# CITY OF BERKLEY, MICHIGAN REGULAR MEETING OF THE CITY PLANNING COMMISSION

Tuesday, August 23, 2022 7:00PM — City Hall Council Chambers Information: 248-658-3320

Subject: SP-14-22; 3860 Twelve Mile Rd., America's Stamp Stop – Site Plan Review

Subject: PSP-10-22 Vinsetta Garage Eaton and Oxford Parking Lots Site Plan Approval

SITE PLAN,
GENERAL
NOTES,
ZONING
&LOCATION
MAP

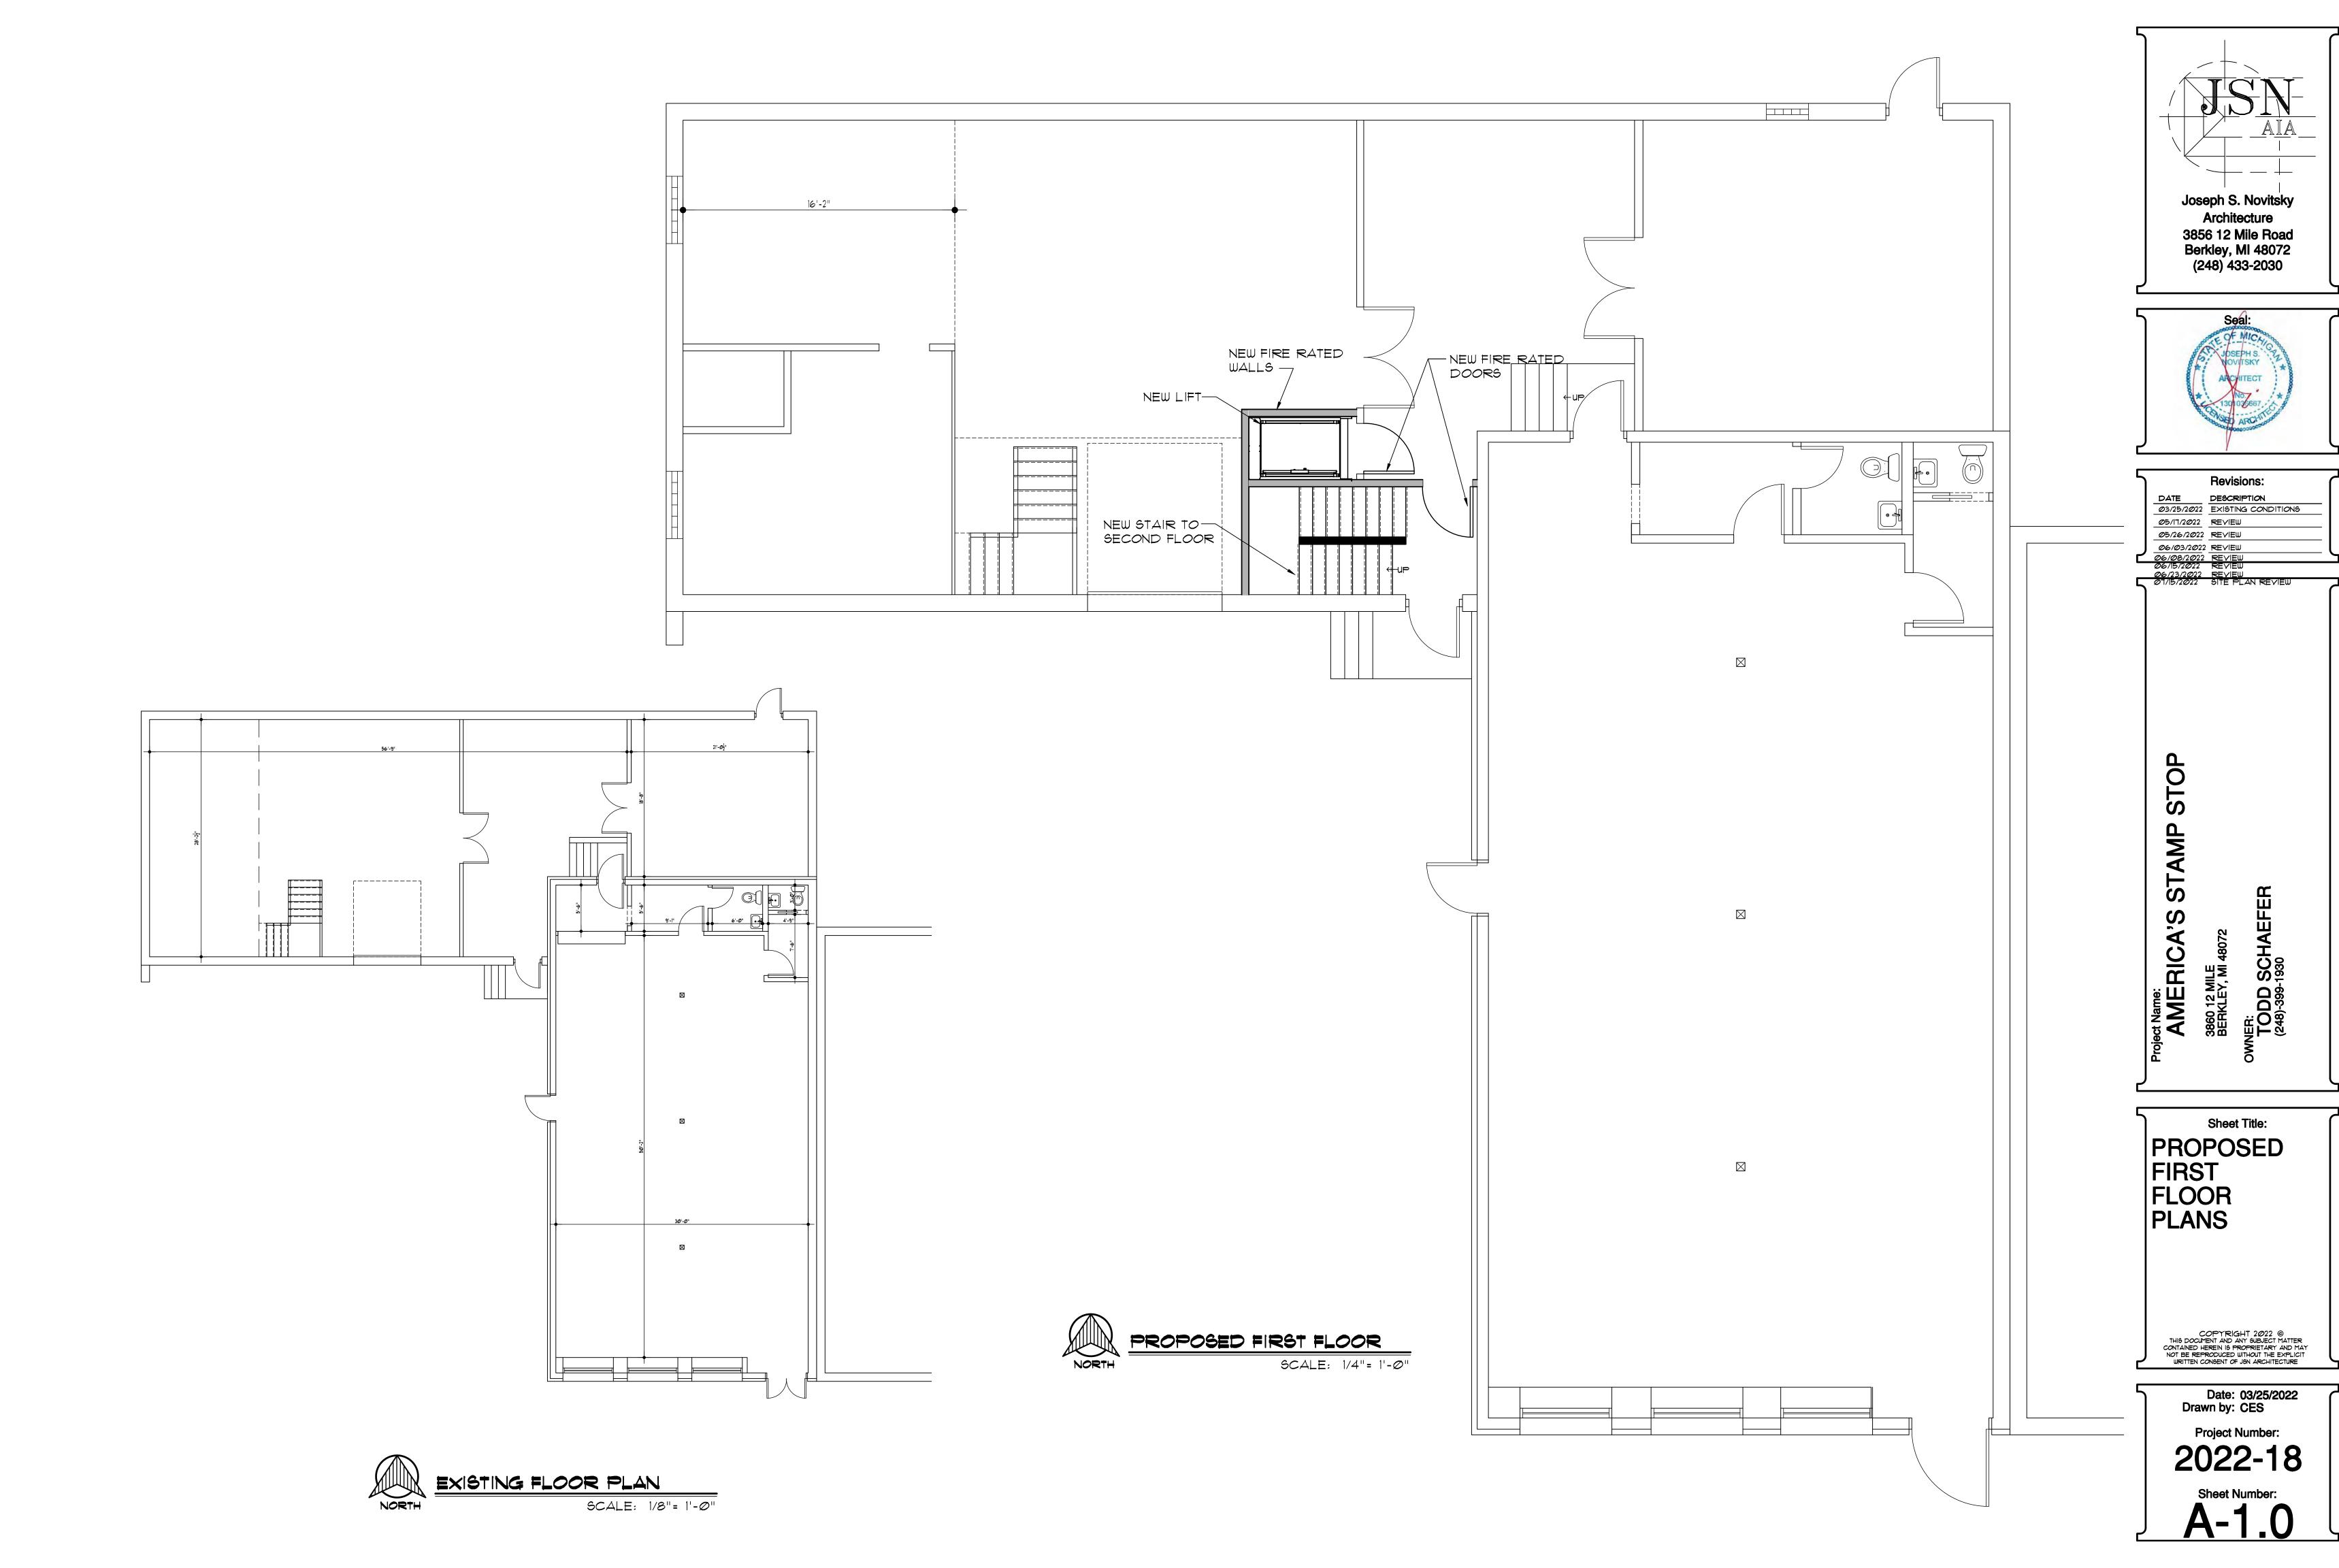
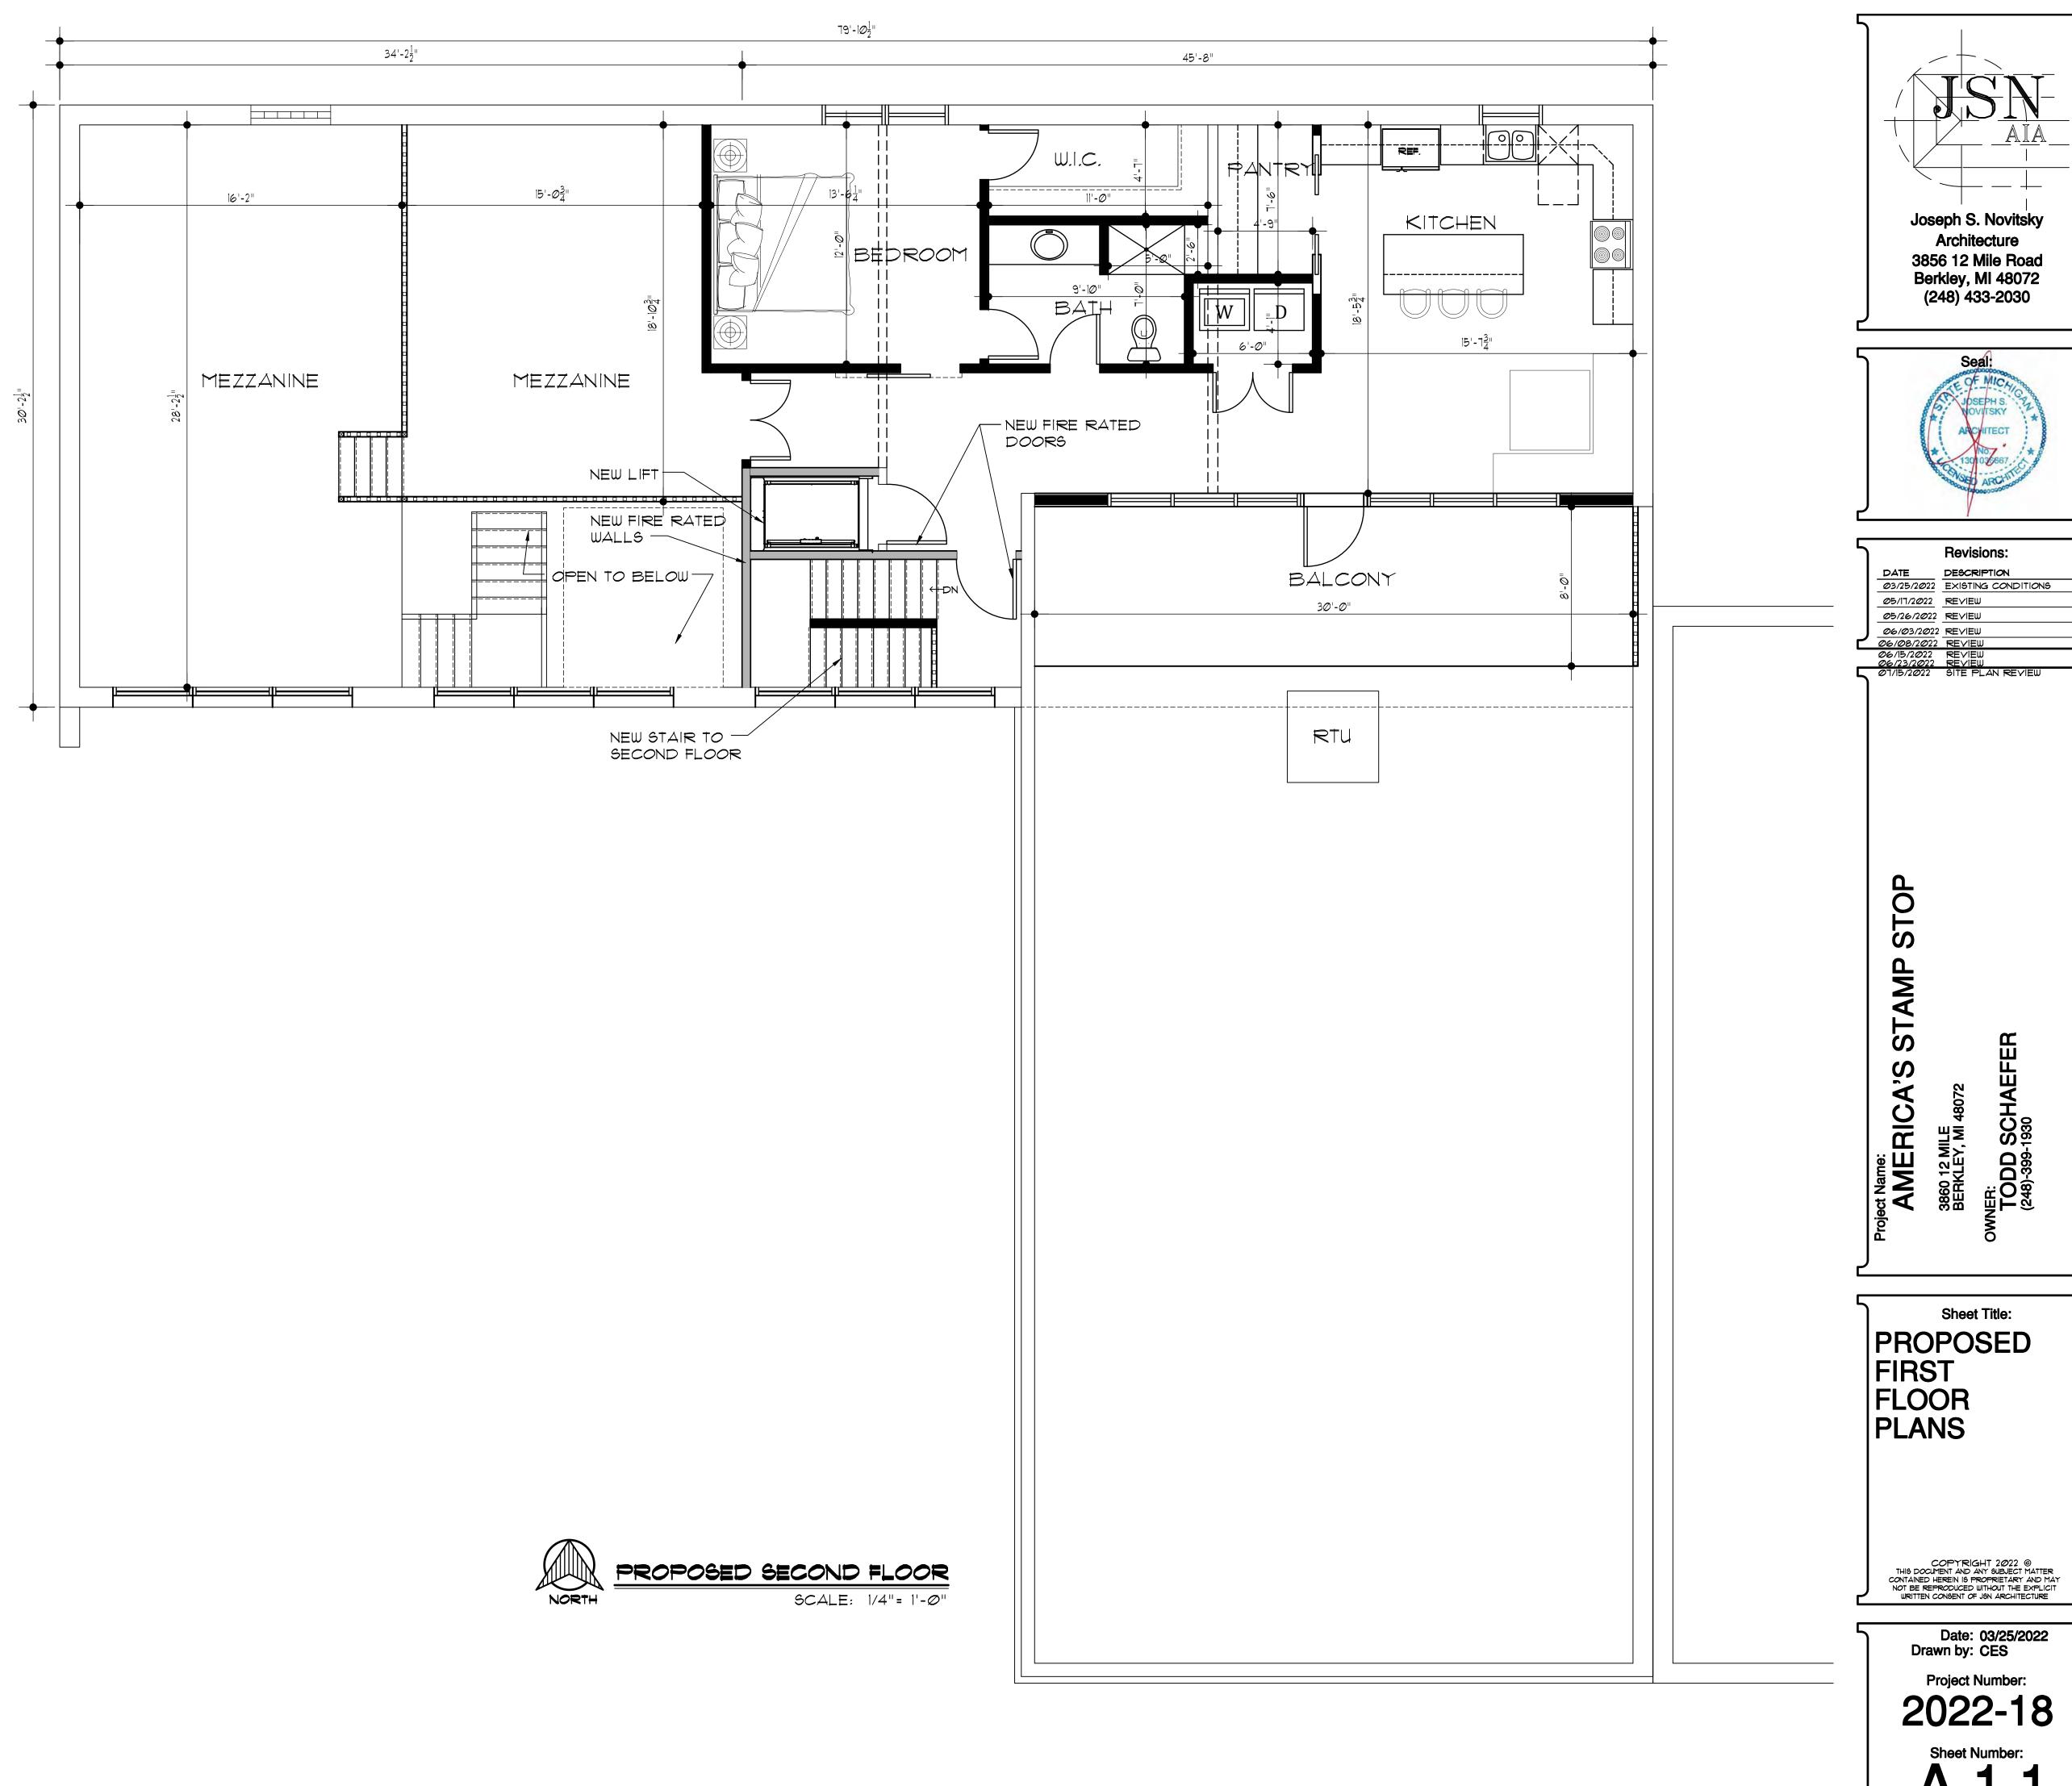
The applicant shall provide a sample of materials for Planning Commission consideration.

No changes in landscaping or site design are proposed with this application besides the addition of a bike rack. No new exterior lighting is shown. If new exterior lighting is proposed, it must be shown on the plan and photometrics and manufacuturer's cut sheets should be provided.

- 1. The applicant should submit a response letter including the calculations for window coverage on the south façade. The Planning Commission can permit a reduction in the required window coverage of the Twelve Mile Rd. facade if the proposed facade meets the intent of the Ordinance.
- 2. The Planning Commission shall determine if the proposed materials and colors fit with the characteristics of the neighborhood.
- 3. Exterior lighting and signage to be reviewed administratively by the Community Development Department.
- 4. Final site plan approval from DPW, Fire Marshal, and Community Development Departments.

The owner has already been in front of the Planning Commission regarding the front windows and was approved by the Planning Commission. They are to remain glass block and not be expanded or changed to storefront windows for security reasons. The current glazing percentage is as follows:

- (3) Windows @28 sq. ft. = 84 sq. ft.
- 84 sq. ft./232 sq. ft. = .362 = 36.2%
- 2) Agreed
- 3) Agreed
- 4) Samples of the proposed materials will be brought to the Planning Commission meeting. The metal siding will lay flat, as it is the finish material of the wall. The glass block on the front (south façade) shall remain for security reasons.
- 5) No new exterior lighting is proposed.
- 6) Agreed
